Changes for next version

2024-07-05 Changes

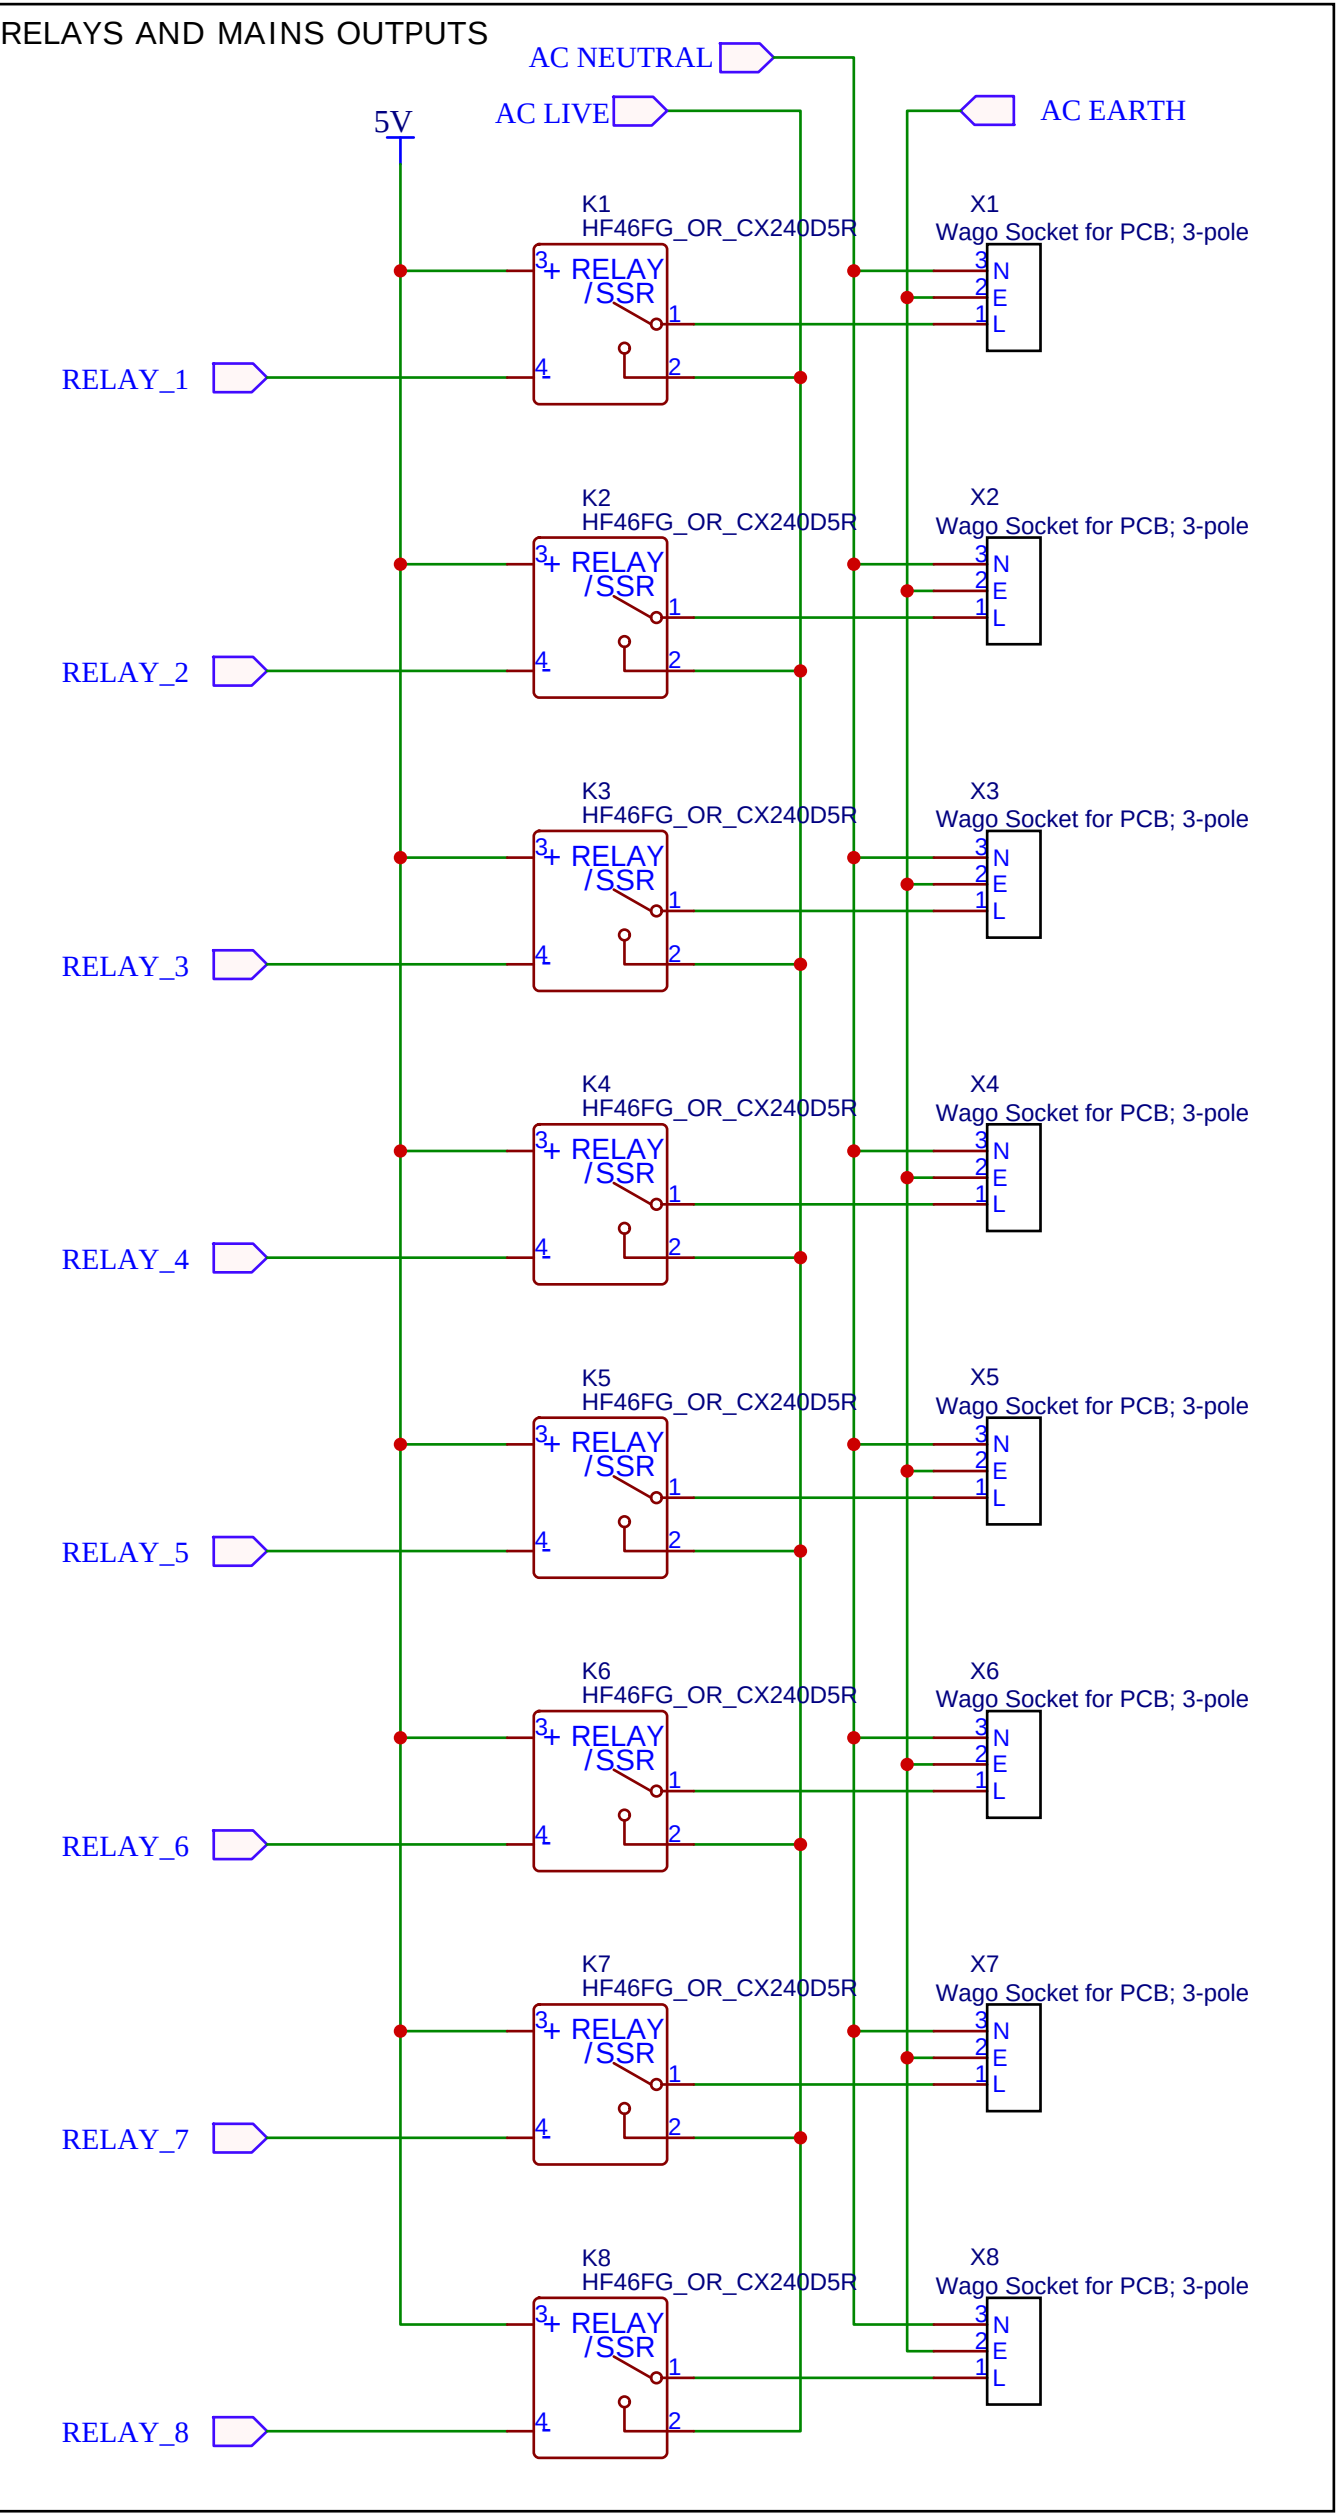
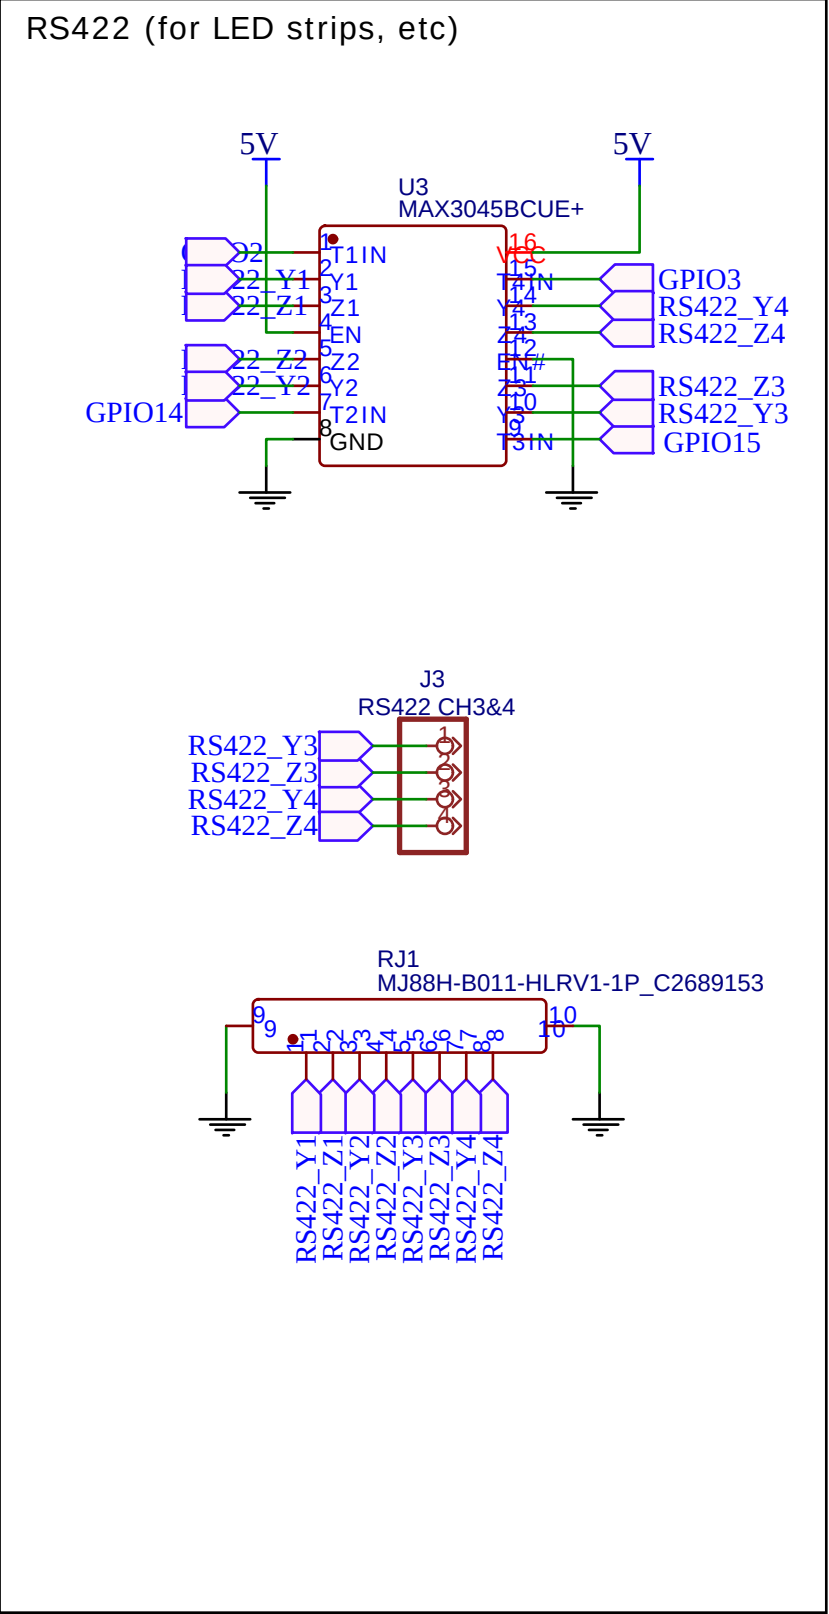
- pull down on ANIN2 10K so not floating on mains sync input
- RJ45 connector is intended to be sunken - change to a non-sunken one
- Make sure the twisted pair assignments on the RJ45 conn make sense even with a regularly wired Cat5 cable
- Change extension ports to IDC connectors 2x10 with one side all grounded
- extension port move up away from mounting holes
- could move smaller mounting holes further apart so lower one near main mounting hole
- Align components better
- Maybe switch to all SMD?
- Silk screen could be improved
- redo silk for poe module mounting
- smaller holes for poe module mounting
- Move relay LEDs up and next to relay
- Move Olimex module down
- Edge mount push buttons
- Move jumpers for RS422 to a better place
- Proto area smaller and maybe more underneath Olimex
-
